Technical Service Bulletin

Transaction No.: 2078397/5

01-25-04 - DTC P0456 Software Update and Hardware Check

Figure 1:

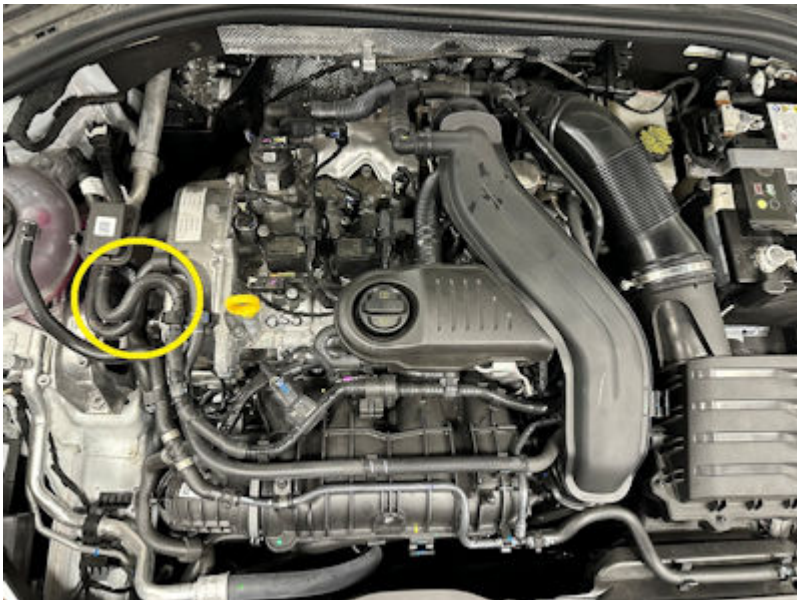
STEP 4: Inspect, and if necessary, replace purge line with -N80-

Focus special attention to the area circled in Figure 1.

If a leak is found from the corrugated purge line (shown above) remove and replace the component.

Figure 2:

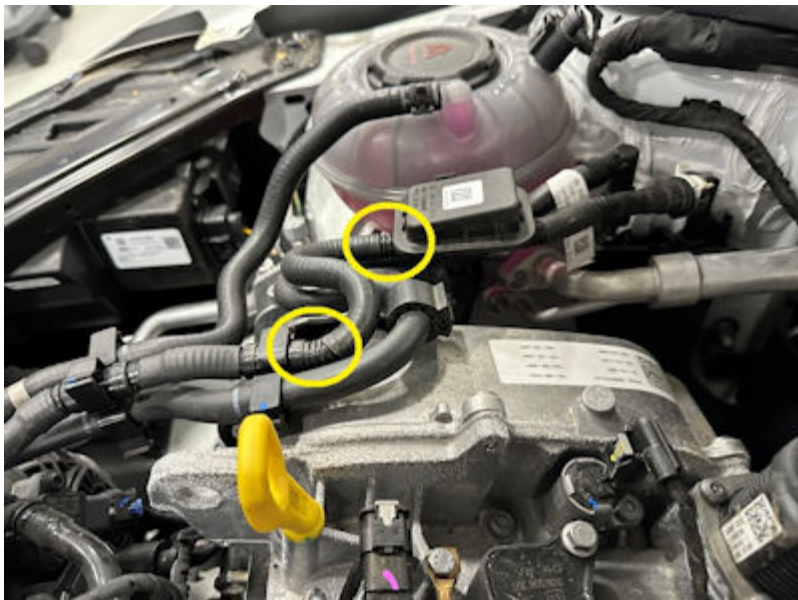
Figure 2 highlights two sections of the purge line from figure 1 that are prone to cracking.
